#### Finding 1: High priority work orders must be tracked.

# Finding 2: The Plant must conduct the required maintenance activities on the Black Start system.

Figure 14: Bird nest in Gas Chromatograph before and after photos.

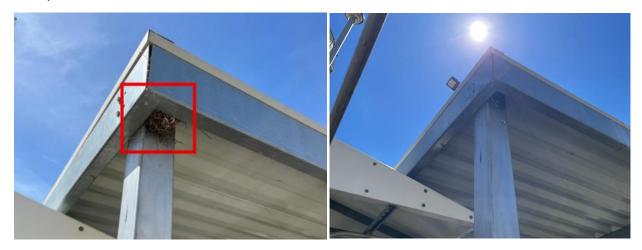
#### Finding 10: Bird nests were present on equipment at the Plant.

Plant contracted our California Energy Commission (CEC) approved Designated Biologist to conduct a site visit and observation of the observed bird nest. Please reference full Report of August 6, 2025, House Finch Nest Inspection and Management Recommendations.

Because the nest was inactive and was a source of concern to regulators, and therefore to MLGS, I removed the empty nest on August 6, 2025, immediately after confirming species identification and inactive status. Active house finch nests are protected under the Migratory Bird Treaty Act and California Fish and Game Code, but inactive house finch nests are not a protected resource. The house finch has an extensive range and is noted by the IUCN Red List as having an increasing population, categorized as "Least Concern."
